UNITED STATES
NUCLEAR REGULATORY COMMISSION
WASHINGTON, D.C. 20555-0001

SUBJECT: SURRY POWER STATION, UNIT NOS. 1 AND 2 – STAFF ASSESSMENT OF
FLOOD HAZARD FOCUSED EVALUATION AND INTEGRATED ASSESSMENT
(EPID NO. L-2019-JLD-0008)

Figure 3.3.1-2: NACCS Save Point 17451 Water Levels Adjusted for SLR (NOAA2017 Intermediate Scenario for 2060)

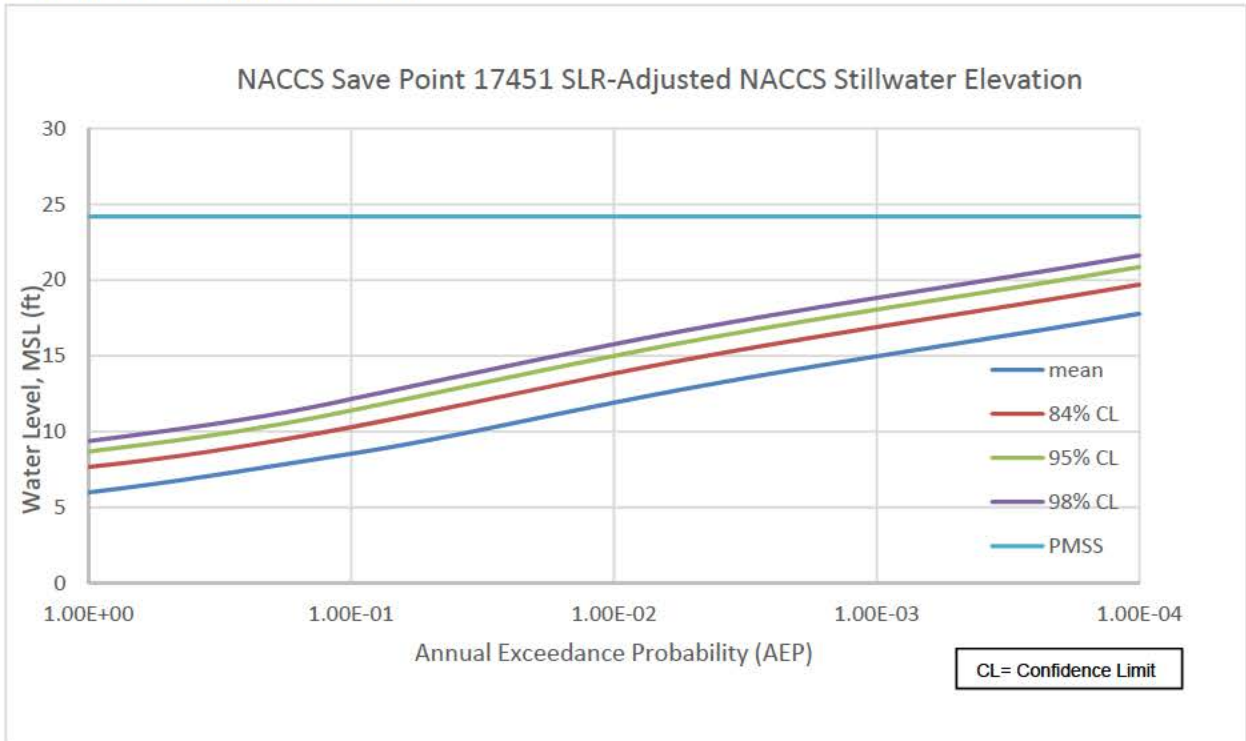
The NRC staff obtained the NACCS stillwater elevation at ADCIRC Save Point 17451 (as a function of annual exceedance probability (AEP)) by using the CHS for base conditions with 96 random tides. Subsequently, the NRC staff adjusted the water levels to account for SLR using the USACE Sea-Level Change Curve Calculator (SLCCC).³ To do this, the NRC staff focused on Sewells Point tide gage location and relied on the SLCCC coupled with the NOAA 2017 Intermediate Global Sea-Level Rise Scenario⁴. The NRC staff found that a projected SLR of 2.4 ft. for the year 2060 was appropriate for consideration. The projected SLR at the Sewells Point gage was linearly added to the NACCS results. The SLR-adjusted NACCS stillwater elevations are shown on Figure 3.3.1-2 of this report.

The deterministic storm surge peak stillwater elevation of 24.2 ft. MSL is also plotted on Figure 3.3.1-2. As shown in the figure, at an AEP of 1E-3, the mean NACCS SLR-adjusted peak SWE is approximately 15.0 ft. MSL and the 98 percent confidence limit is approximately 18.8 ft. MSL. At an AEP of 1E-4, the mean NACCS SLR-adjusted peak stillwater elevation is approximately 17.8 ft. MSL and the 98 percent confidence limit is approximately 21.6 ft. MSL. Based on the
